**RE: Response to Comments**  
**Modification Request No. 10 – Upgrades at the Mary River Mine Site**  
**Mary River Project, Type 'A' Water Licence - 2AM-MRY1325 - Amend. No. 1**

**Table 1 - Baffinland Response to Comments**  
**Modification No. 10 - Upgrades to the Mary River Mine Site**

## SECTION B - B

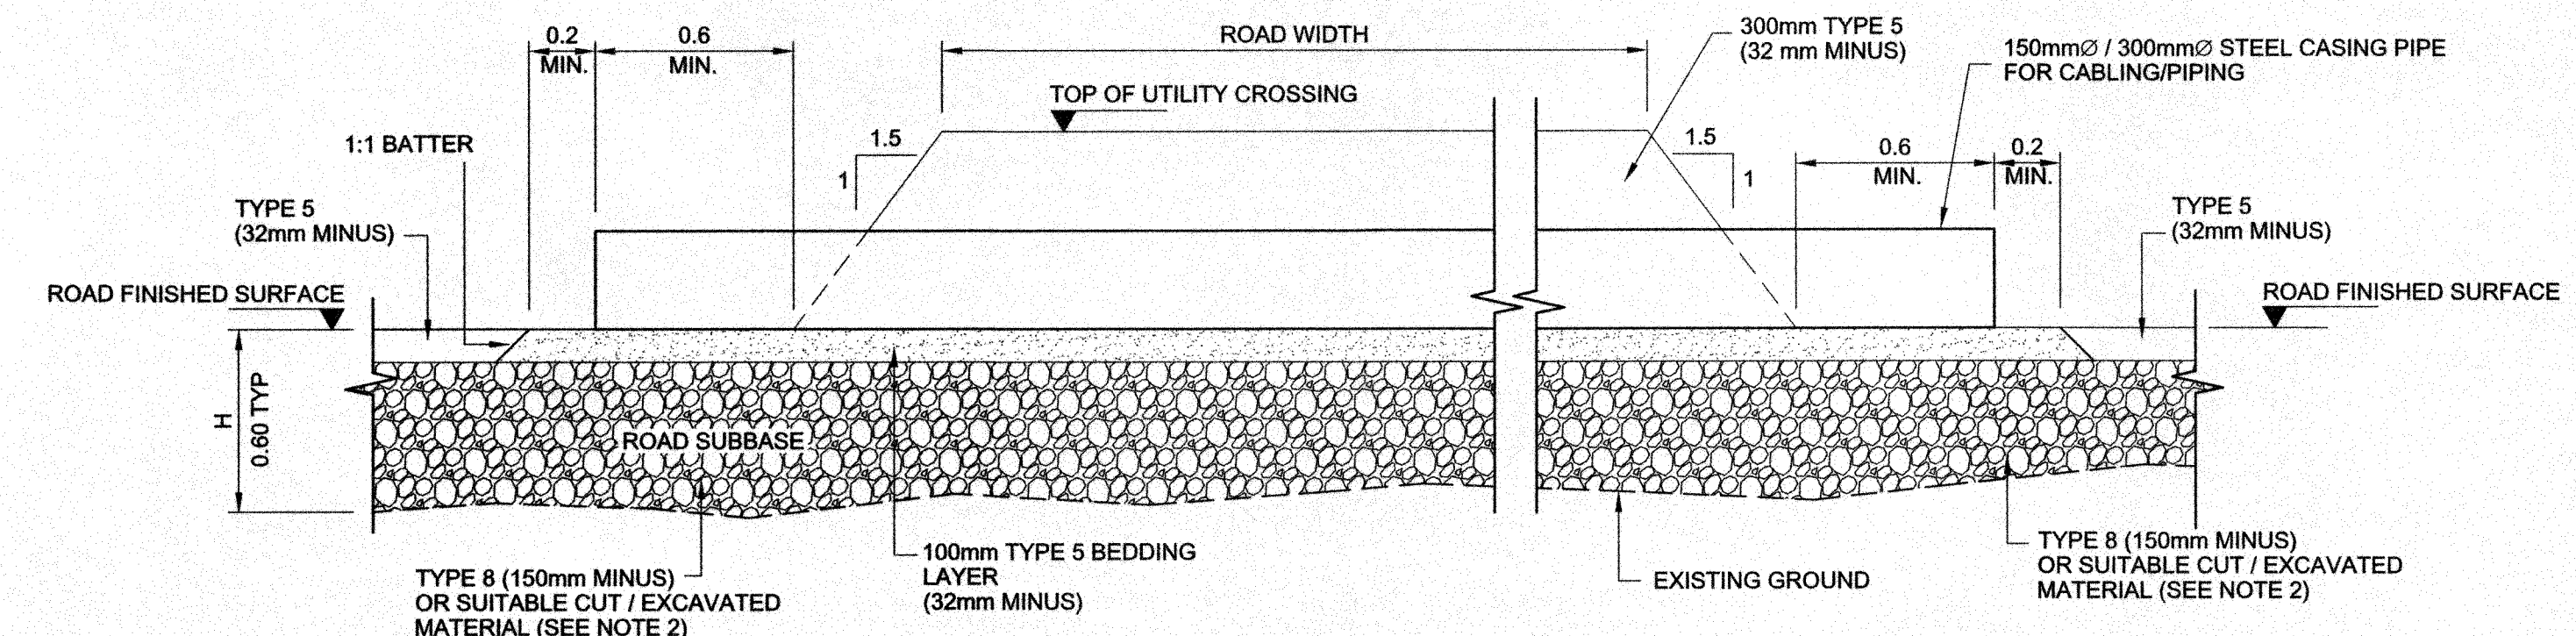
ID	Comment / Recommendation	Baffinland Response
4	<p>Comment:</p> <p>Baffinland proposes to build four (4) culverts to accommodate the crossing of the effluent pipeline across roads. However, specifications and installation details for the culverts are not provided in the submission for Modification Request No. 10.</p> <p><u>Recommendation:</u></p> <p>CIRNAC recommends that Baffinland provide drawings, including specifications showing details (type, material, dimensions, and extensions), for all four culverts, and that an engineer field checks the designs as they are implemented.</p>	<p>To facilitate passage under roadways, the effluent discharge line will be installed within 300 mm diameter steel pipe sleeves, approximately 15m in length. A site wide typical for road crossings of utility corridors is provided in Attachment No. 2, Drawing No. H353004-00000-221-294-0004-0001. All materials will be sourced from approved quarry and borrows.</p>
